August 3, 1984

HOPE CREEK GENERATING STATION  
DOCKET NO. 50-354  
DRAFT SAFETY EVALUATION REPORT  
OPEN ITEM STATUS

In addition, enclosed for your review and approval (see Attachment 4) are the resolutions to the Draft SER open items, FSAR question responses and structural geotechnical audit item responses, listed in Attachment 3.

FIGURE A-16-13

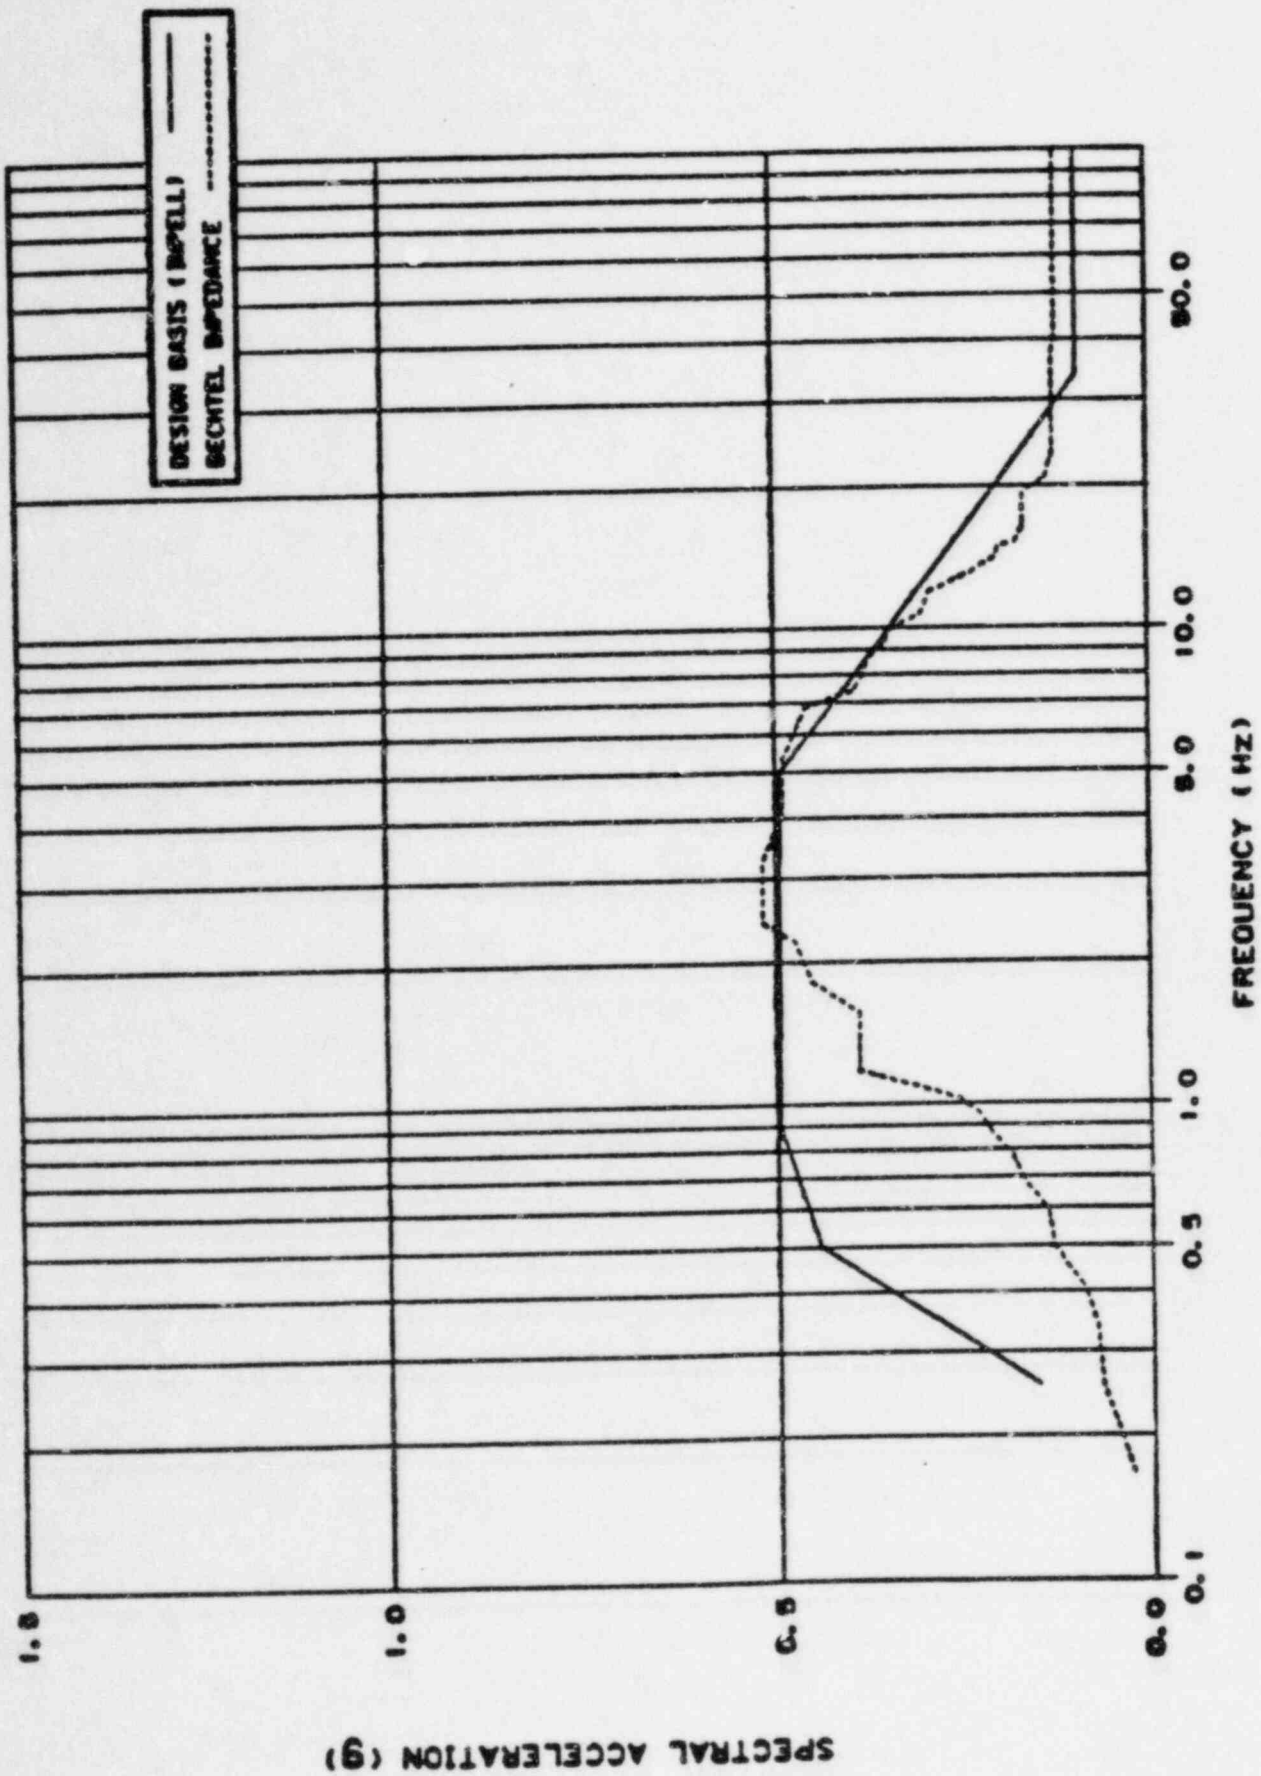
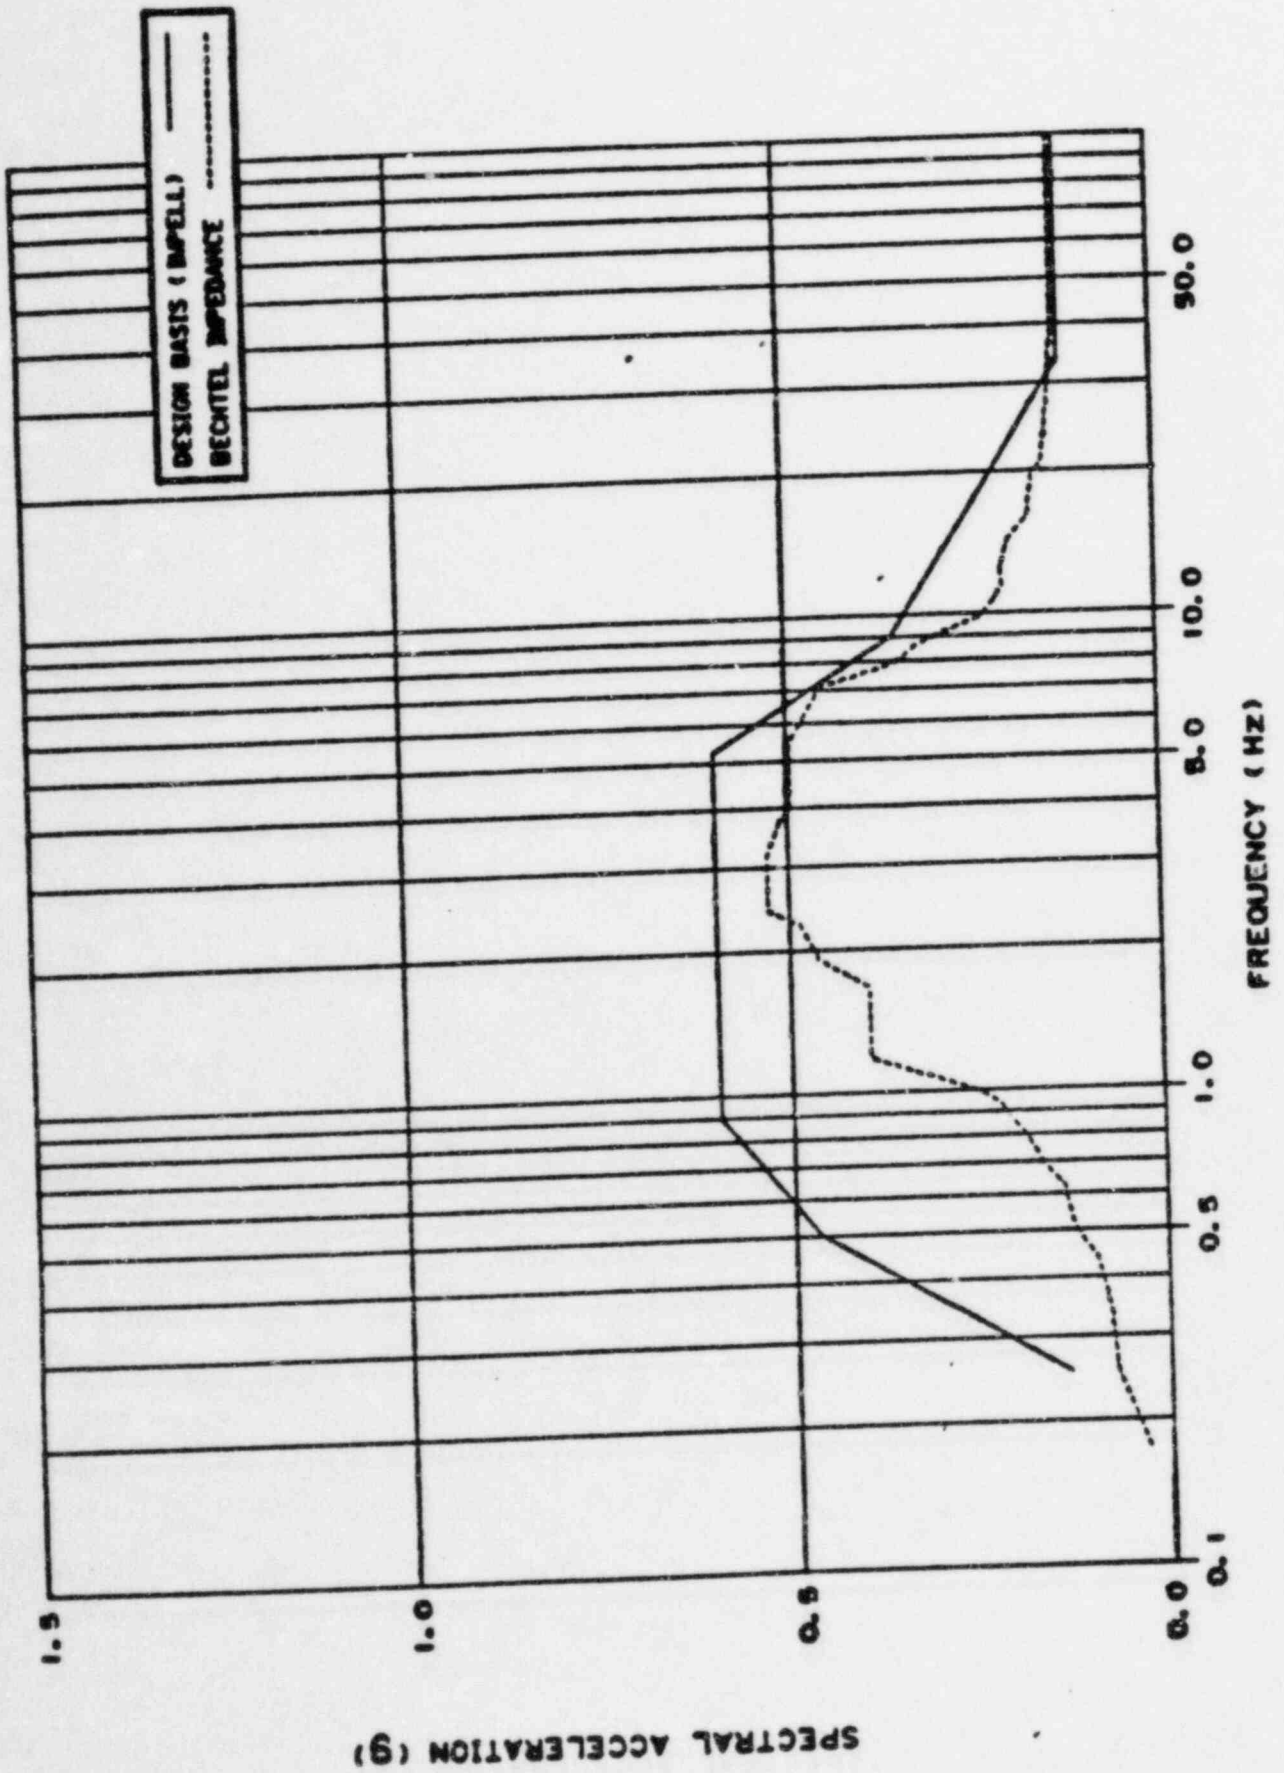
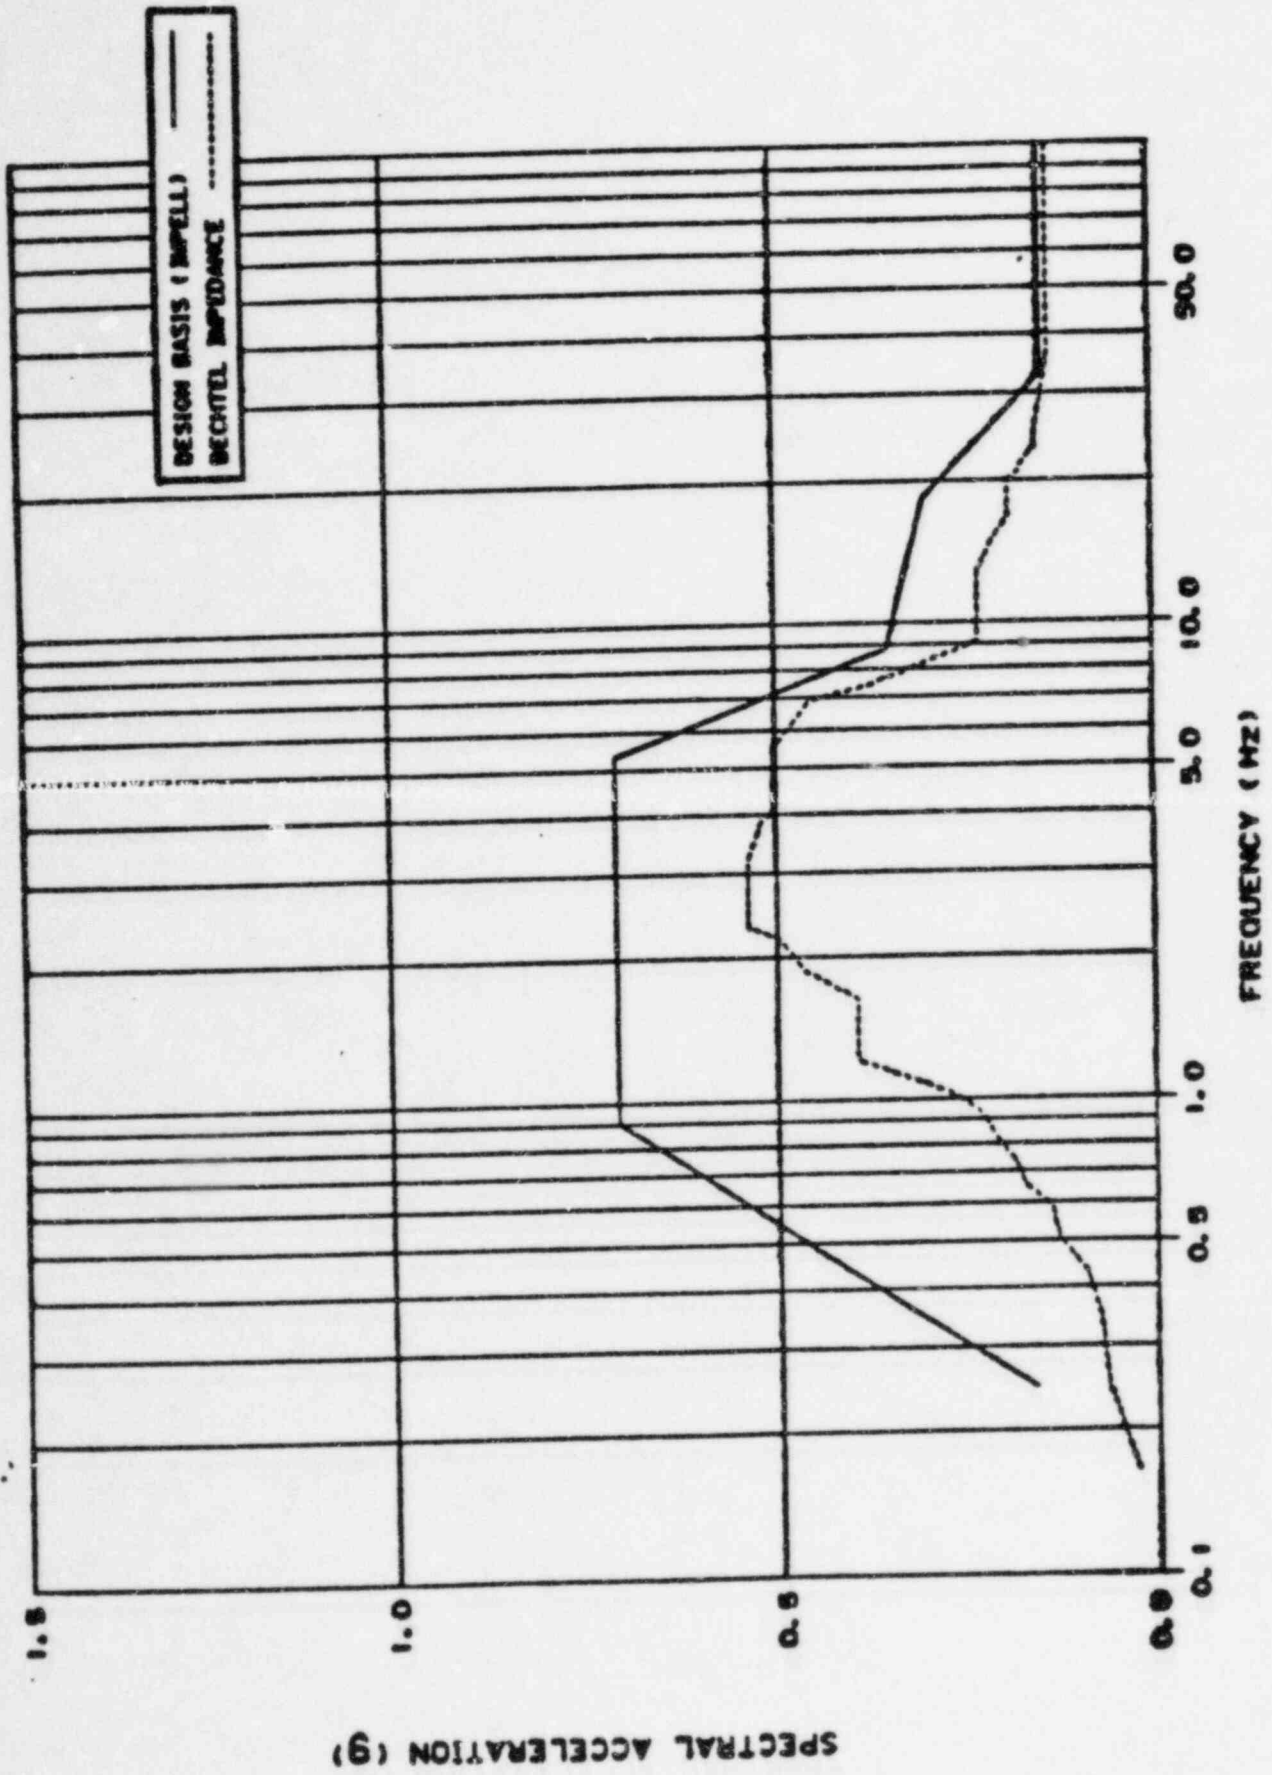
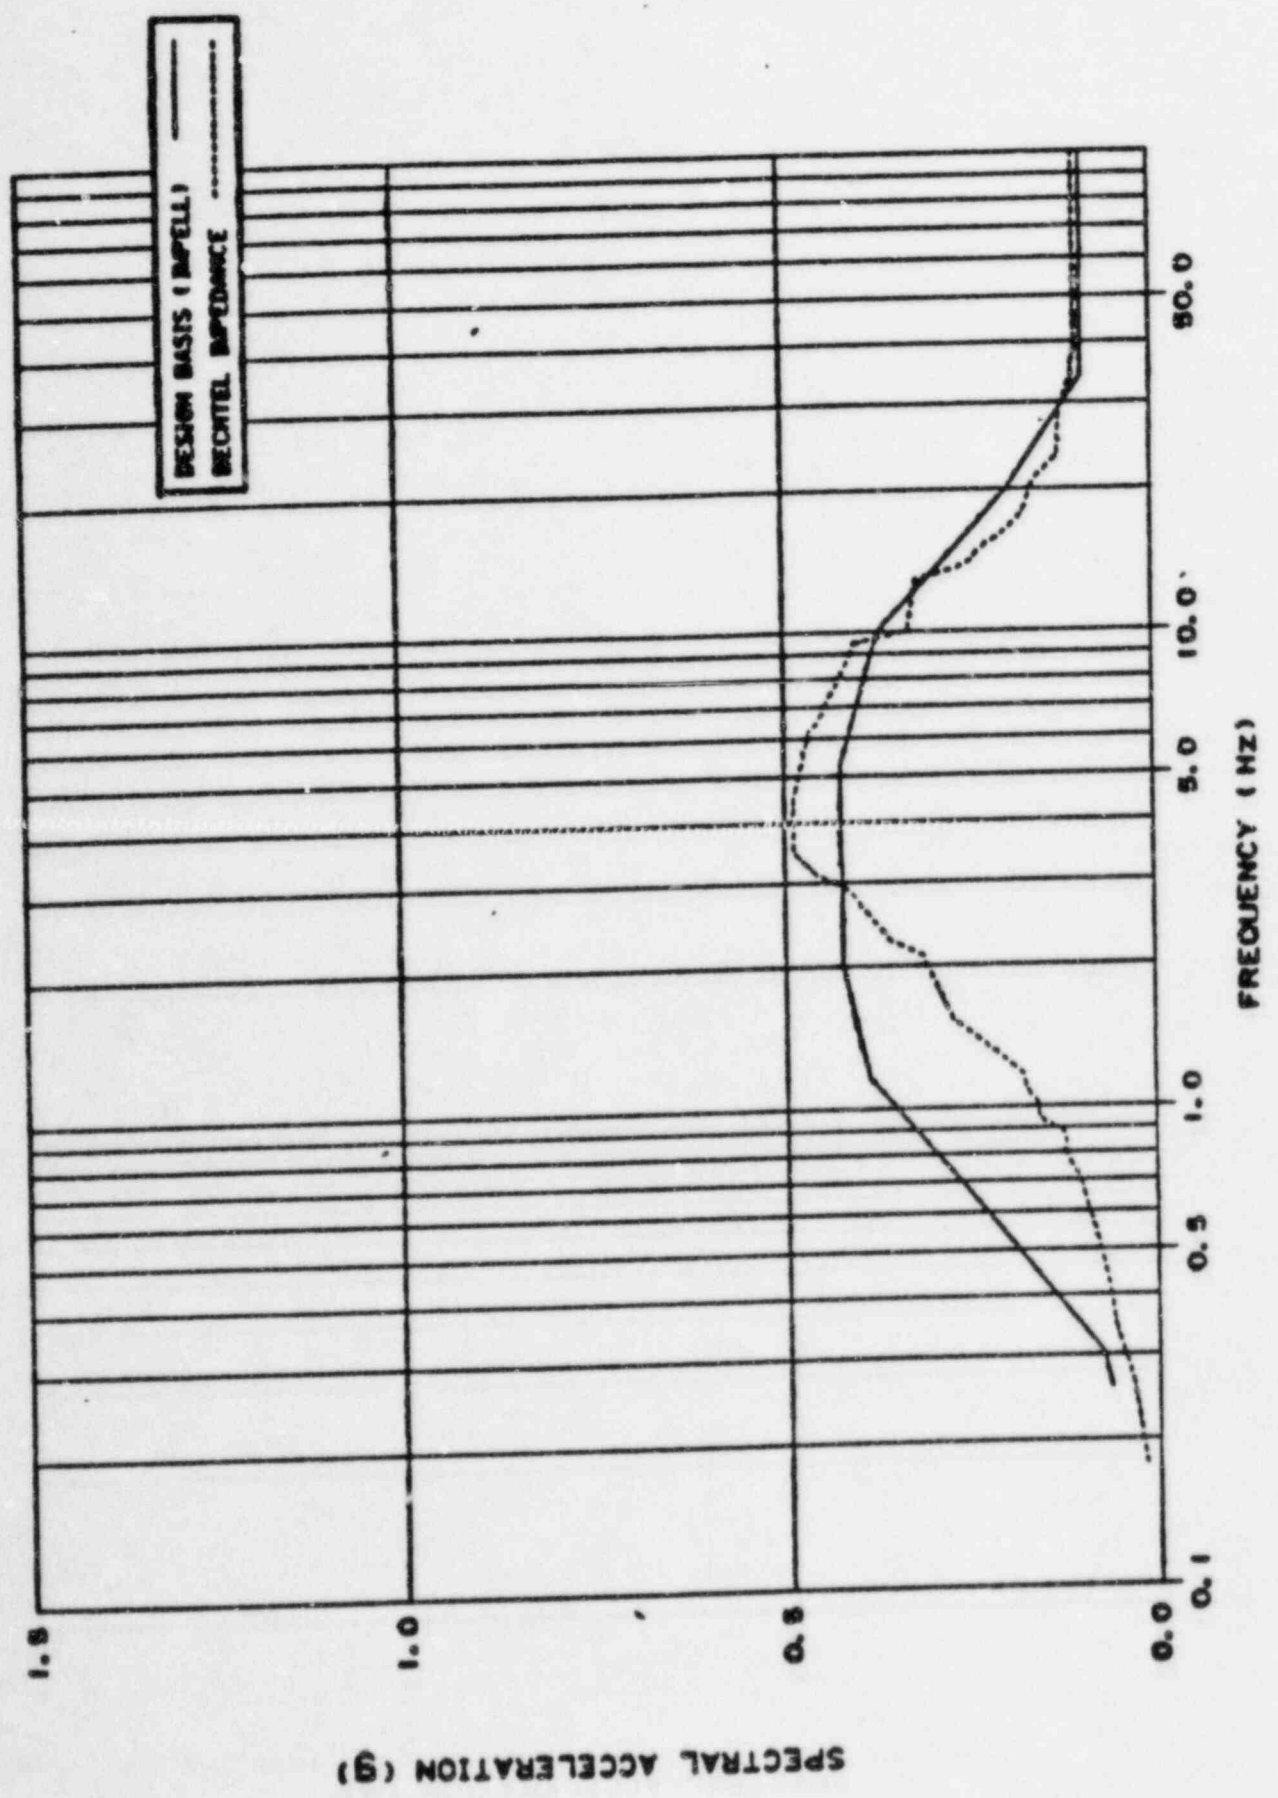
Response

Figures A-16-1 to A-16-18 show the comparison of the 2 percent damping response spectra obtained from the design basis finite element and the impedance approach seismic soil-structure interaction analyses. The impedance approach response spectra generally are enveloped by those obtained from the design basis analyses at elevation 114.0 feet of the SWIS. For other elevations, the impedance approach spectral accelerations exceed the design basis spectral accelerations in some frequency ranges. These ranges vary approximately between 1.5 and 10.0 Hz.
